Serial: RA-17-0035
July 20, 2017

CATAWBA NUCLEAR STATION, UNIT NOS. 1 AND 2
DOCKET NOS. 50-413 AND 50-414
RENEWED LICENSE NOS. NPF-35 AND NPF-52

MCGUIRE NUCLEAR STATION, UNIT NOS. 1 AND 2
DOCKET NOS. 50-369 AND 50-370
RENEWED LICENSE NOS. NPF-9 AND NPF-17

**SUBJECT: SUPPLEMENT TO LICENSE AMENDMENT REQUEST PROPOSING
CHANGES TO CATAWBA AND MCGUIRE TECHNICAL SPECIFICATION 3.8.1,
"AC SOURCES - OPERATING"**

Intake Section

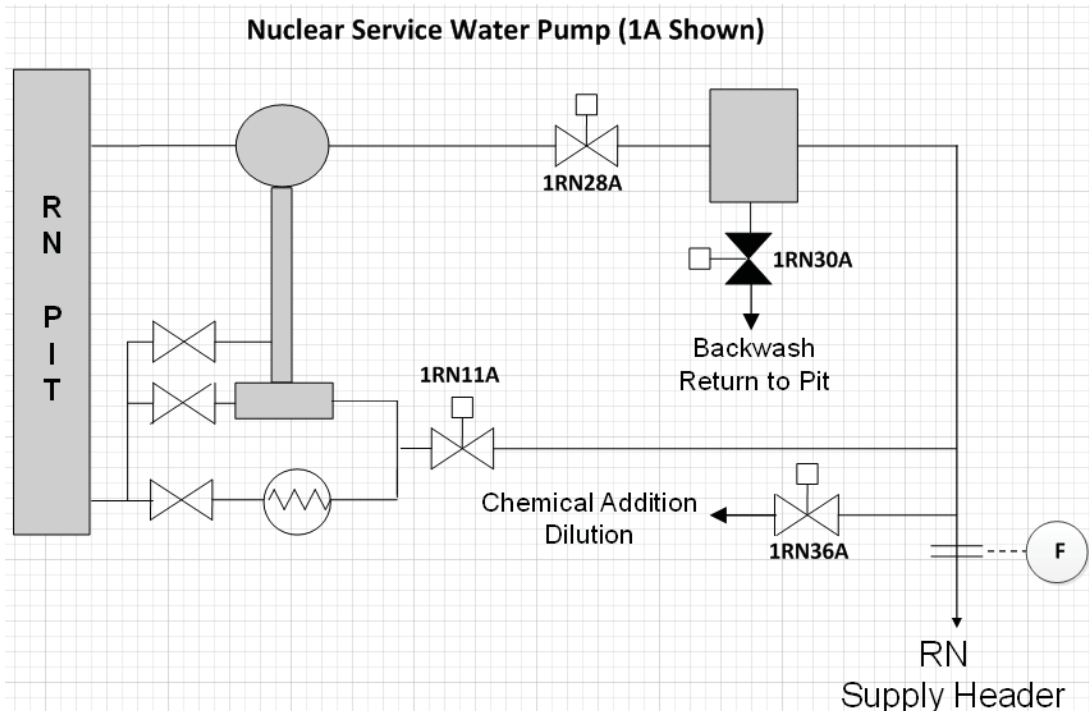
- a. Provide in detail the effects of a loss of each DG would have upon the shared SSCs of the Catawba and McGuire NSWS system to evaluate the effect upon each unit.

Valves 1RN1A and 1RN2B are normally open to align Lake Wylie to Nuclear Service Water Pump Intake Pit A. Nuclear service water pumps 1A and 2A draw suction from intake pit A. Valves 1RN1A and 1RN2B close on emergency low level in either RN pumphouse pit (based on 2 out of 3 logic from single pits level instruments) to isolate the RN System from Lake Wylie for RN alignment to the Standby Nuclear Service Water Pond (SNSWP).

1RN5A and 1RN6B perform the same function for the B intake pit.

A loss of the 1A EDG would potentially result in the inability of valves 1RN1A and 1RN5A to close if there was a concurrent loss of offsite power and a dam failure resulting in a low intake pit level. The corresponding B train valves, 1RN2B and 1RN6B, would close to prevent the drainage of the SNSWP to the empty Lake Wylie.

The single train related supply valves from the SNSWP, 1RN3A and 1RN4B, are normally closed. Upon receipt of a low intake pit level, these valves open to provide the assured RN system supply from the SNSWP. In the loss of EDG 1A and dam failure event, 1RN3A may remain closed; however, 1RN4B would open to supply water to the RN system.
